RE: Revised Perc Cert Plan
Nursery View Lots 8 & 9
File No: F-10-87

RE: Plat of Resubdivision Review Comments
Nursery View Lots 8 & 9
File No: F-10-87

RE: F-10-87/Nursery View, Lots 8 and 9, Sec. 3

**RE: File Number: F-10-087
Nursery View Lots 8 & 9 Sec. 3
Old Frederick Rd**

PLAT OF REVISION
LOTS 8 AND 9, SECTION THREE
NURSERY VIEW
(A REVISION OF LOT 7, SECTION TWO, NURSERY VIEW PREVIOUSLY RECORDED IN PLAT BOOK 27 AT PAGE 39 AND TAX PARCEL 3)

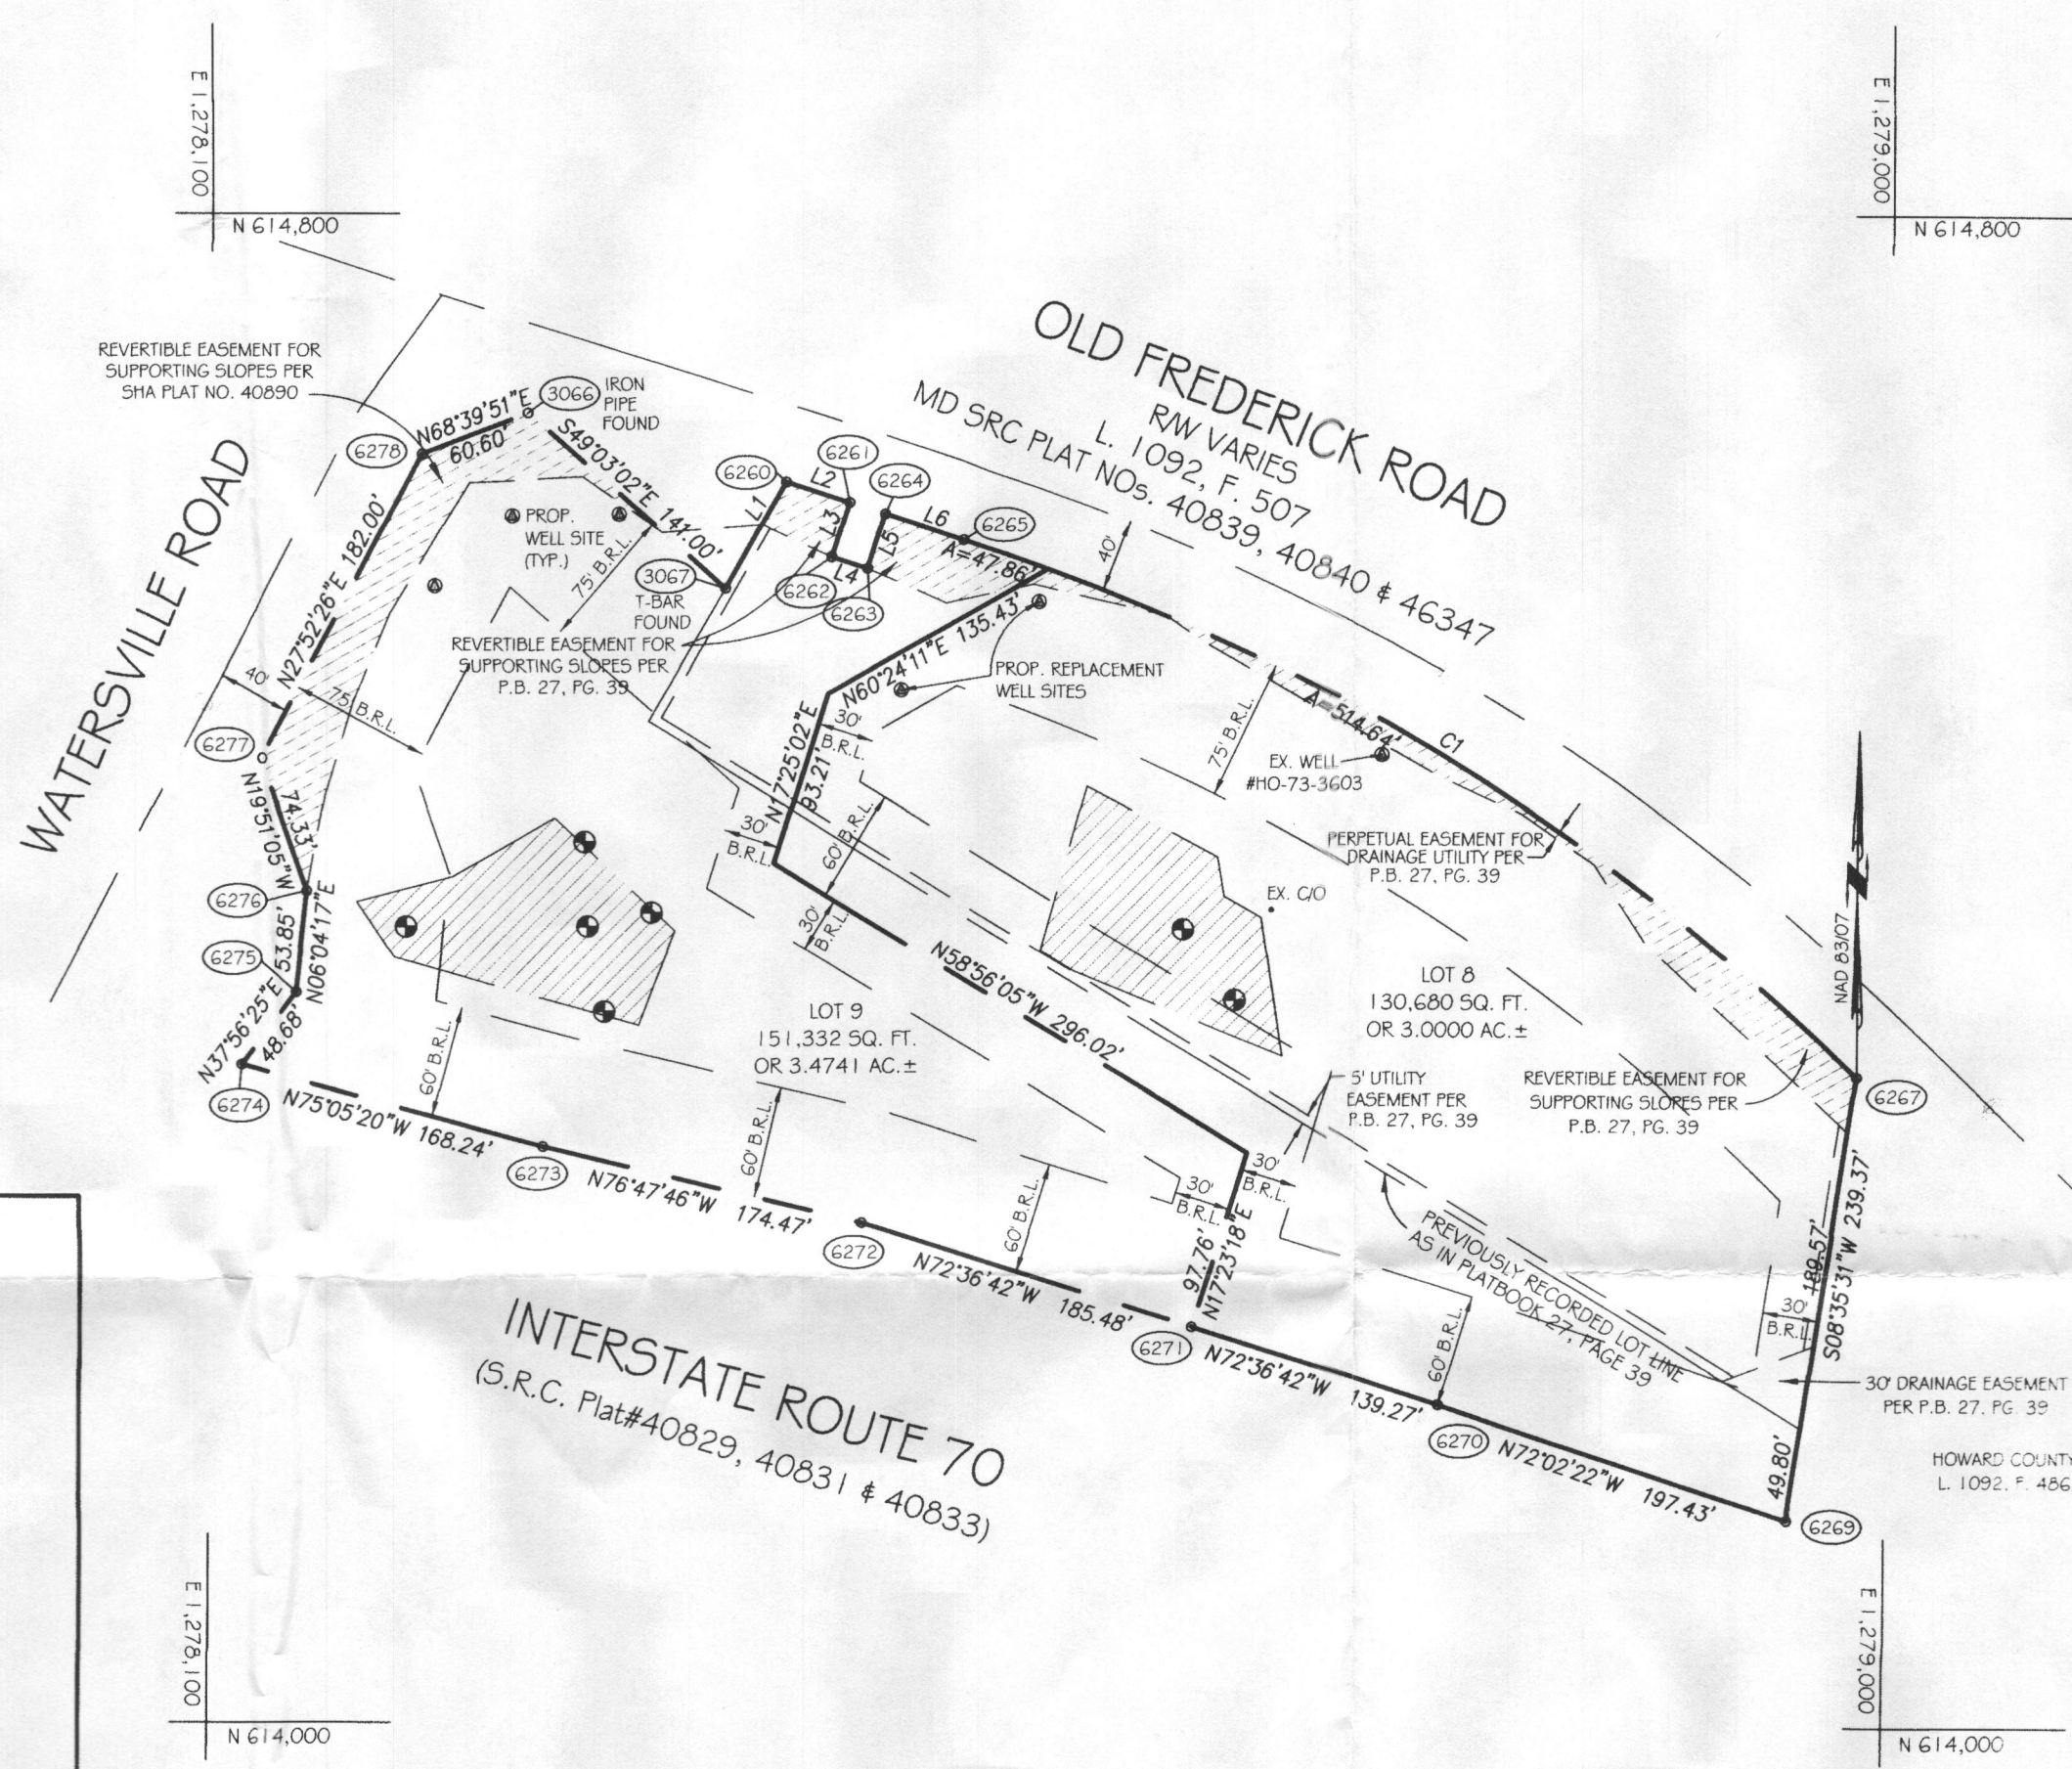
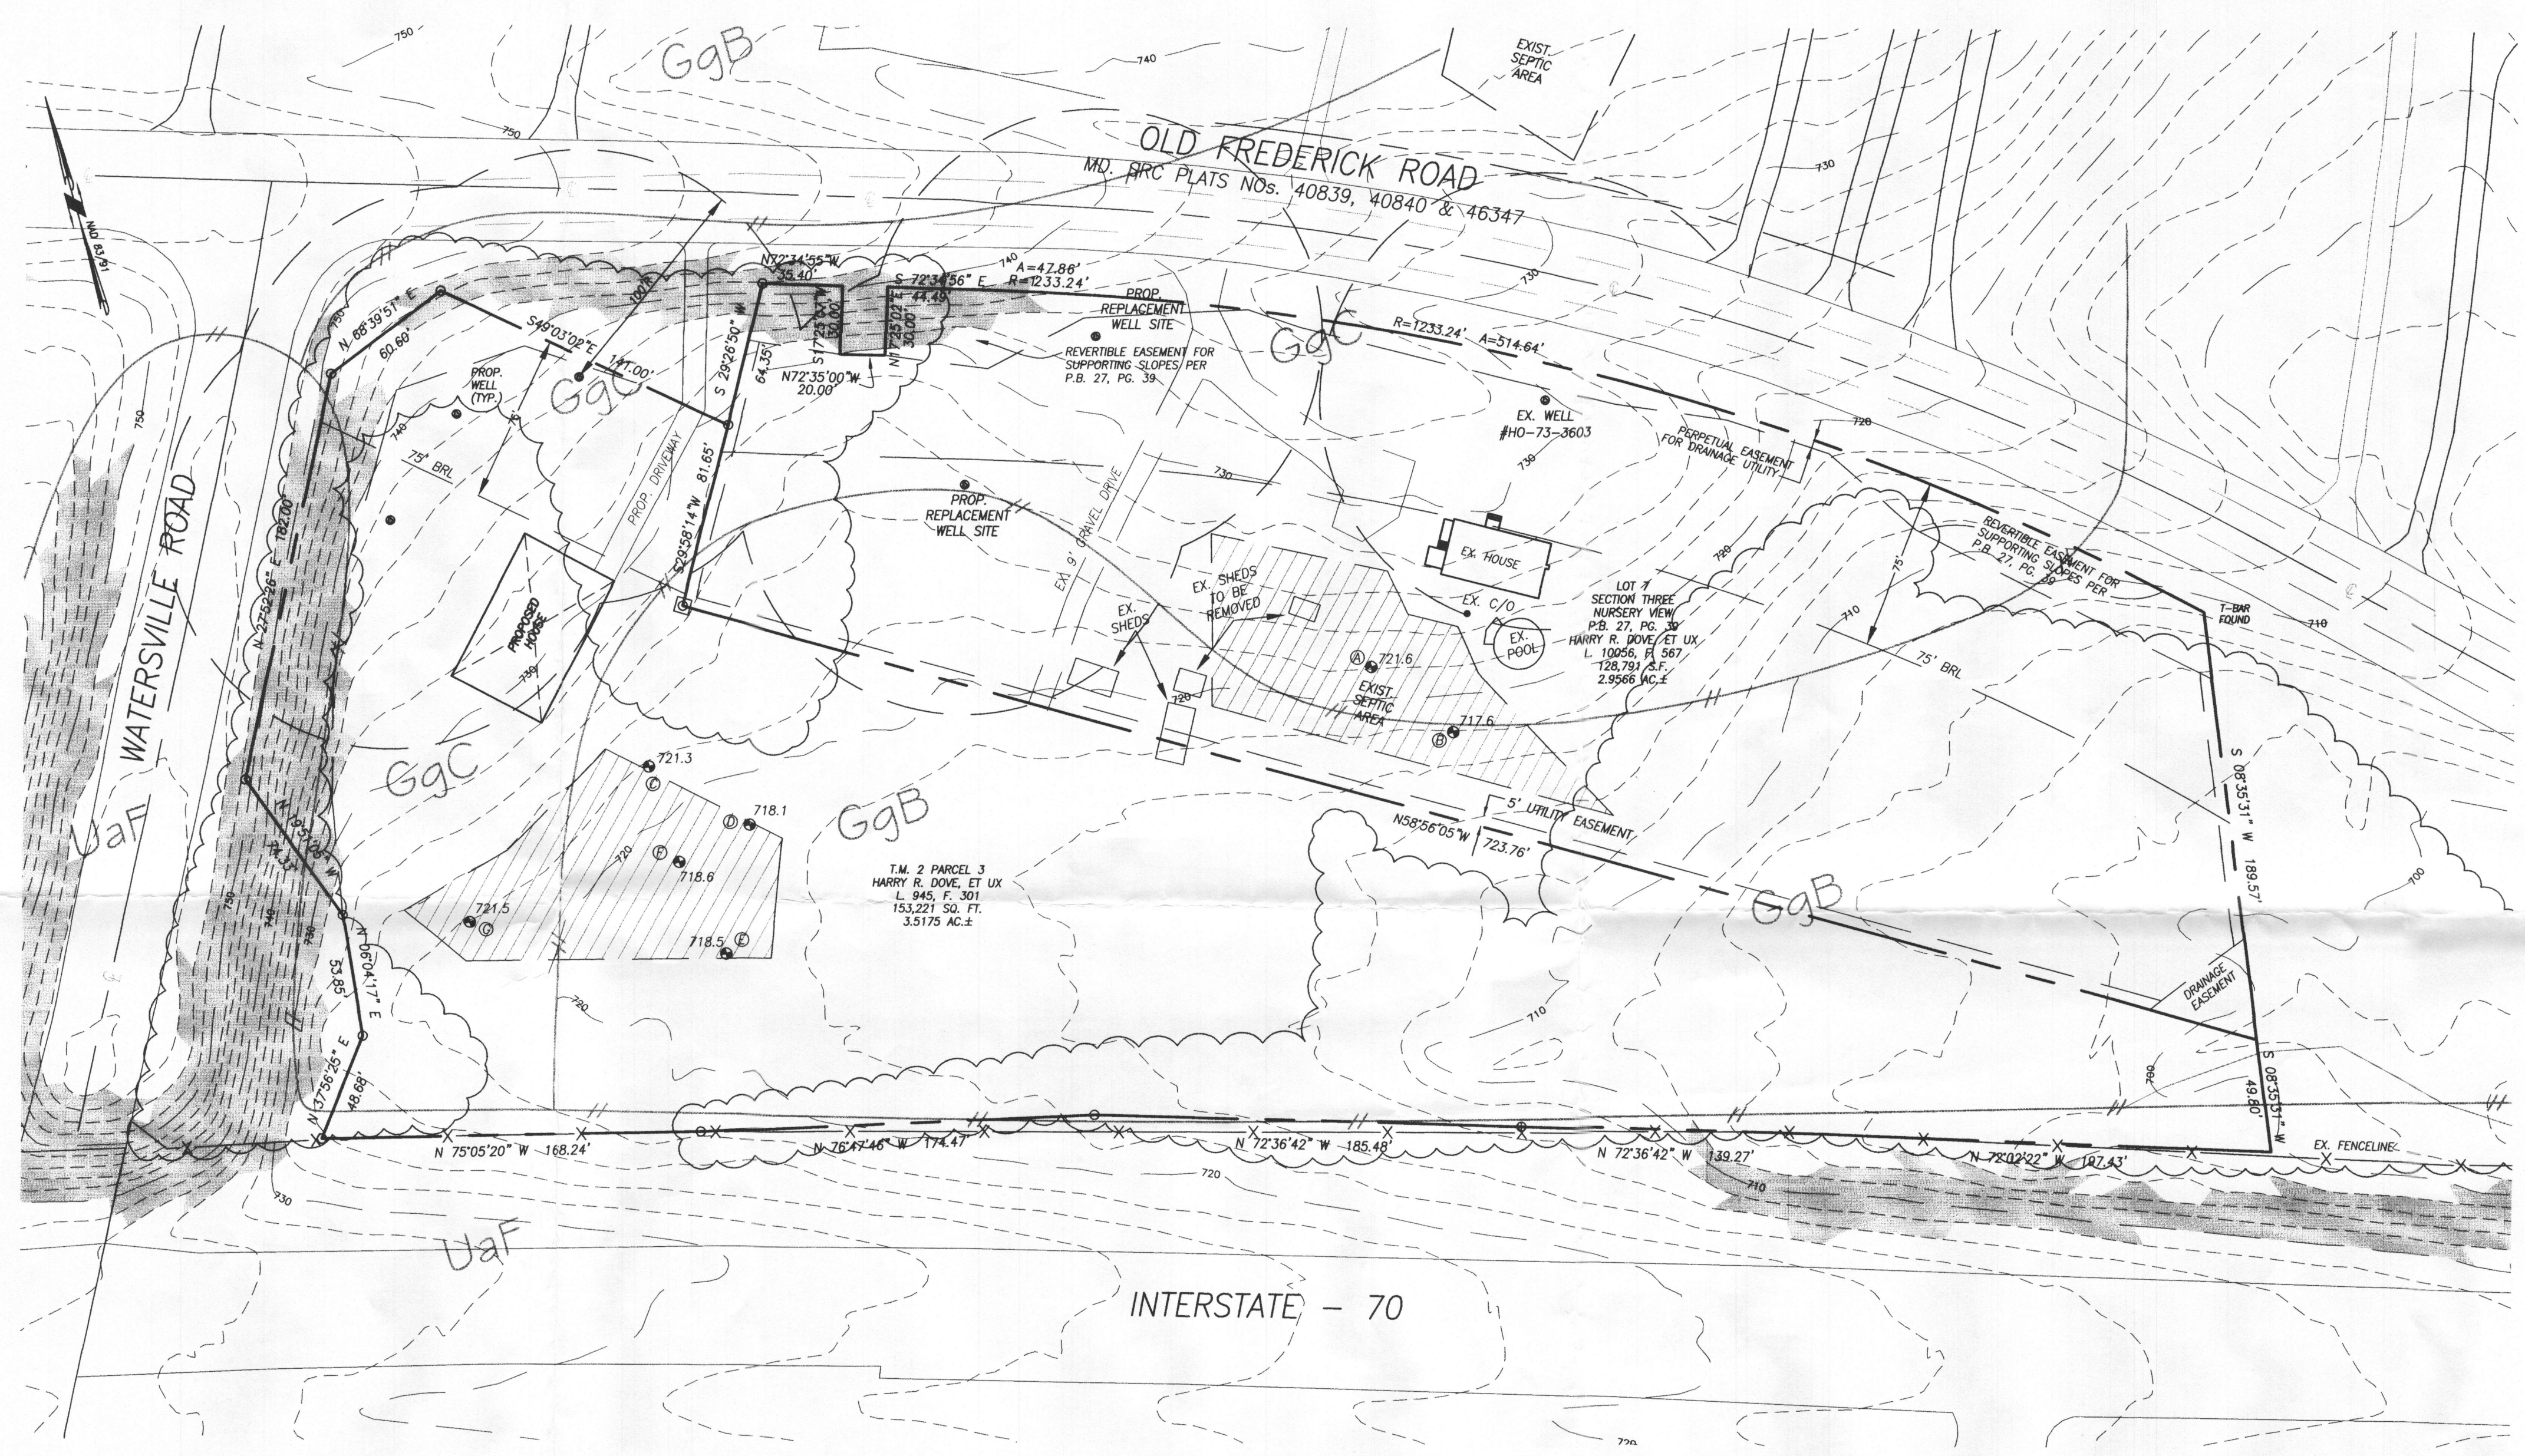
1. On Lot 9, correct southern BRL from 60' to 75.' The owner is advised that the eastern 30' BRL may also change should the Development Engineering Division require a noise study. Orientation of the house would then be dictated by location of the noise contour. The 65 dBA can not enter the rear yard unless mitigation is provided or a waiver petition is approved (Sec.16.120)(b)(5).

2. All roadways are access restricted. Accordingly, the owner should consider at this time the creation of a use-in-common access easement for ingress/egress for both lots onto Old Frederick Road. The access should be established at an approved location reviewed by the Development Engineering Division and the State Highway Administration.

2. Correct Note No. 18 to indicate: . . . Amended 5th Edition "of the" Subdivision and Land Development Regulations . . .
3. Correct Note No. 20 to indicate: . . . to be extinguished upon recordation of "this" plat.

4. Verify and add the following note: No cemeteries exist on the subject site.
5. Label the road classifications of Old Frederick Road and West Watersville Road, label the centerlines and add the ROW widths.

6. Label the frontage of each lot along Old Frederick Road (except at the approved entranceway to both lots), along Rt. 70 and along West Watersville Road as "Vehicular Ingress/Egress Restricted."

7. Add to the labels for the 5' Utility Easement and Previously Recorded Lot Line: "to be Abandoned by Recordation of this plat."
8. Label the 5' eastern easement located on Lot 8.

9. Correctly label "West" Watersville Road on the plat and in the Vicinity Map.
10. Correct the word "revision" located in all notes (Note Nos. 15,16 & 19) and in the Title Block to indicate: a "resubdivision."

11. Add the zoning classification to the adjoining eastern property.

- II.C.1. - On Plat sheet 1 and Topography/Soil/SWM Exhibit, please revise the General Notes to include Noise Study information and provide SWM information based on 2010 SWM regulations that will be enforced from May 4, 2010. Erase the General Note 16 since this plat is not only adjust the common lot lines between former lot 7 and parcel 3 but also change parcel 3 into a buildable lot.

- III.A.2. - On Plat sheet 1 and Topography/Soil/SWM Exhibit, please show the adjacent right-of-ways, street names, street classifications, Existing and proposed R/W width.

- IV.A.1. - On Plat sheet 1 and Topography/Soil/SWM Exhibit, please check right-of-way dedication with the current Howard County General Plan of Highways and approved construction drawings. Provide right-of-way dedication language if it is applicable.

- IV.A.5. - On Plat sheet 1 and Topography/Soil/SWM Exhibit, please include access restriction
